Char Development and Settlement Bridging Project (Phase IV Additional Finance) Bangladesh

Quality Control of Main Hydro-morphological Study of Meghna Estuary

Technical Report No. 5

CDSP-B(AF) Quality control analysis of main hydro-morphological study Meghna estuary

Figure 2-1: Amplitudes of M2, S2, N2, K1, and O1 tidal constituents for the measurements, IWM model and Svašek model at 3 different locations in the Meghna Estuary.

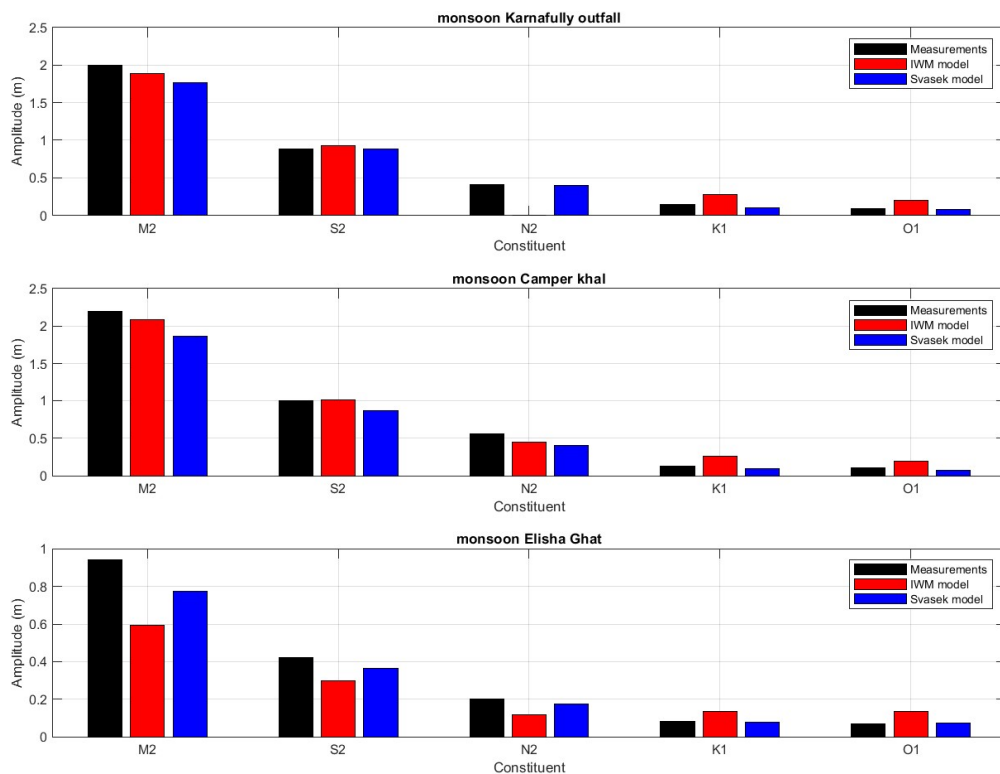
- More insight can be provided by not only looking at the total water level time-series but separating them in a mean, tidal and residual timeseries. Subsequently, tidal analysis can be applied to see spatial and seasonal variations in the amplitude and phase of the different tidal components (M2, S2, etc.). For an example see Figure 2-1.
